WESTINGHOUSE NUCLEAR SAFETY
SAFETY EVALUATION CHECK LIST

- 1) NUCLEAR PLANT(S) : BYRON/BRAIDWOOD UNITS 1 & 2
- 2) SUBJECT (TITLE): RELAXATION OF MSSV SETPOINT TOLERANCE TO +/-3%

BYRON/BRAIDWOOD UNITS 1 AND 2
INCREASED MAIN STEAM SAFETY VALVE SETPOINT TOLERANCE
SAFETY EVALUATION

Figure 2.

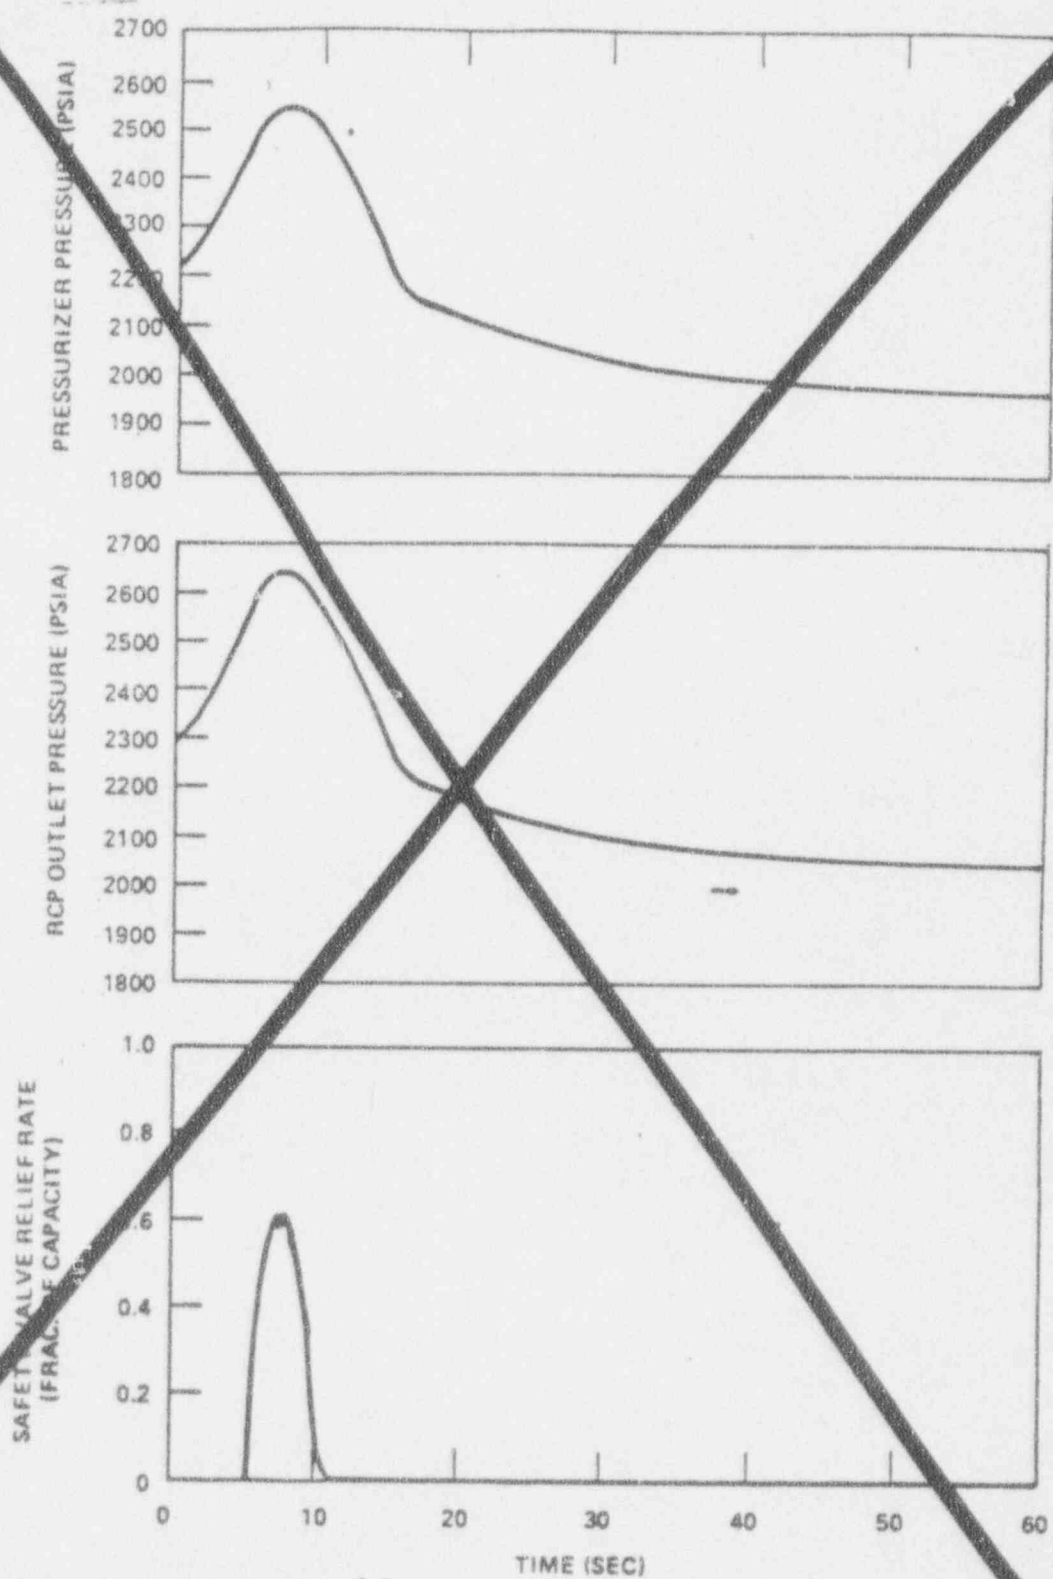
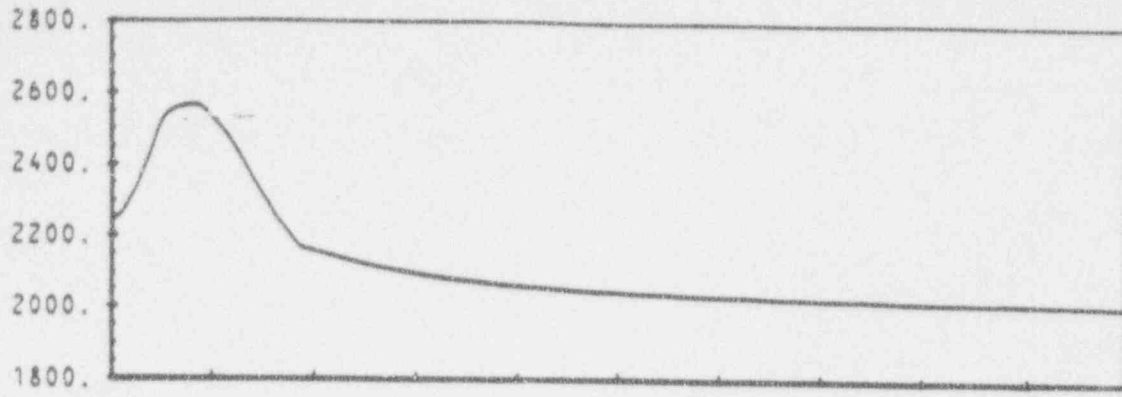
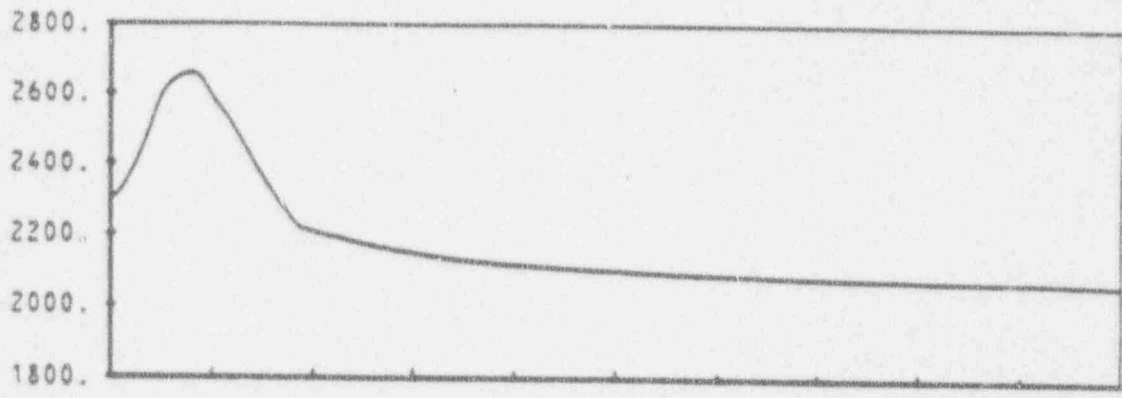
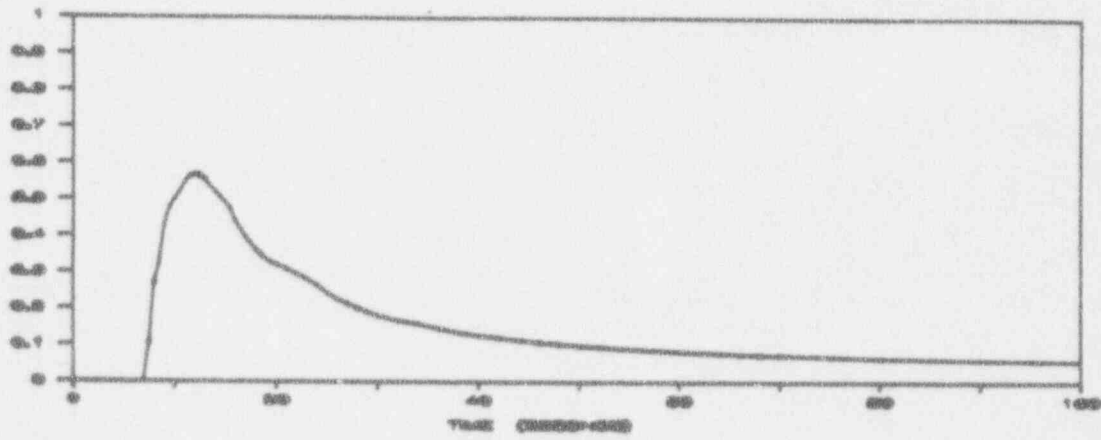
The results of the Turbine Trip transient are shown in Figures 2 and 3. Figure 2 shows the pressurizer pressure, the reactor coolant pump discharge pressure, which is the point of highest pressure in the RCS, and the pressurizer safety valve relief rate. Figure 3 shows steam generator shell side pressure, reactor coolant loop hot leg and cold leg temperature, and nuclear power. The reactor is tripped on a high pressurizer pressure signal for this transient.

Replace with
the following
Figure.

FIGURE 15.0-1

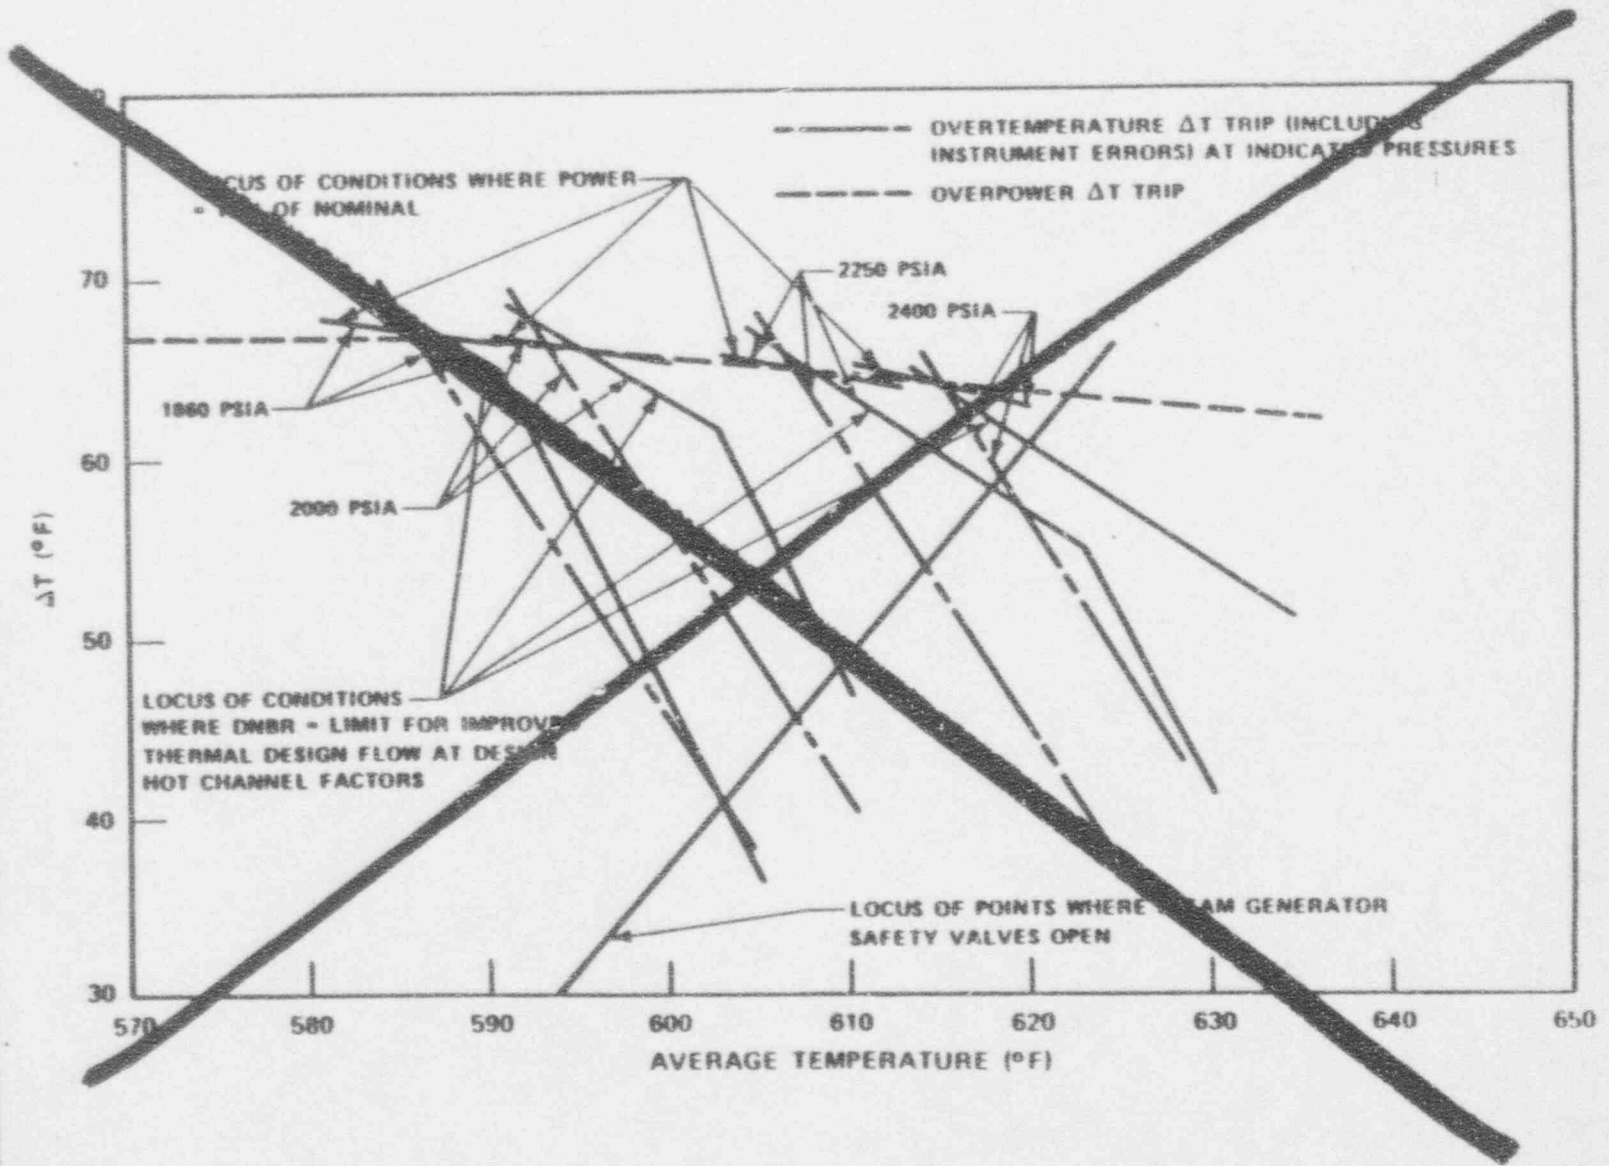
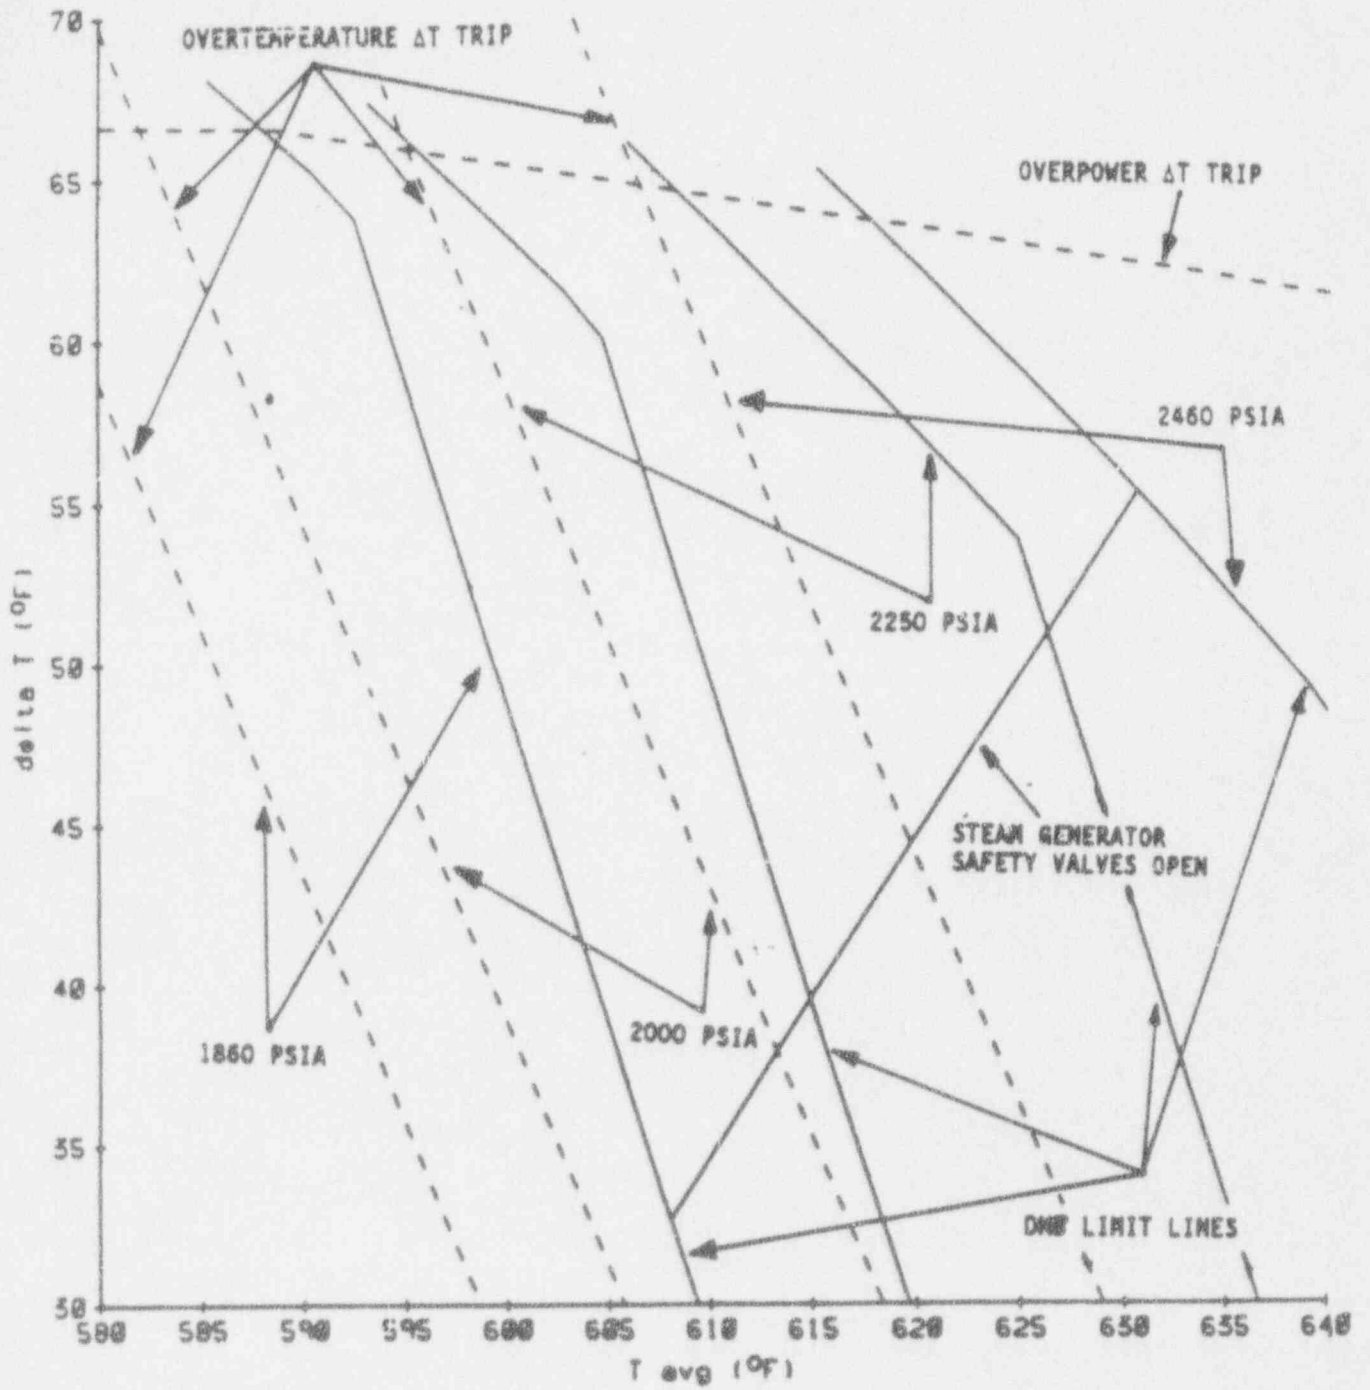
Table 15.0-2, Table 15.0-5, Figure 15.0-1, and Section 15.2.3 were revised based on the new analyses (DT protection and LOL/TT).

The increase in the MSSV lift setpoint tolerance has the potential to impact the Overtemperature ΔT and Overpower ΔT setpoint equations. Referring to UFSAR Figure 15.0-1, increasing the point at which the MSSVs lift will lower the steam generator safety valve line. If the current OT ΔT setpoint coefficients (K1 through K3) result in protection lines that just bound the thermal core limits, it is possible that by lowering the SG safety valve line to the right, a portion of the core limits will be uncovered.

In order to evaluate the effects of the increase in the setpoint tolerance, the Overtemperature ΔT and Overpower ΔT setpoint equations (K1 through K6) were examined to determine if the equations remained valid assuming that all 20 MSSVs opened with a +3% tolerance. The results of that evaluation showed that there was sufficient margin in the generation of the current setpoint equations to offset the lowering of the SG safety valve line. The results of this calculation are presented as Figure 1.

REPLACE WITH
The following
Figure
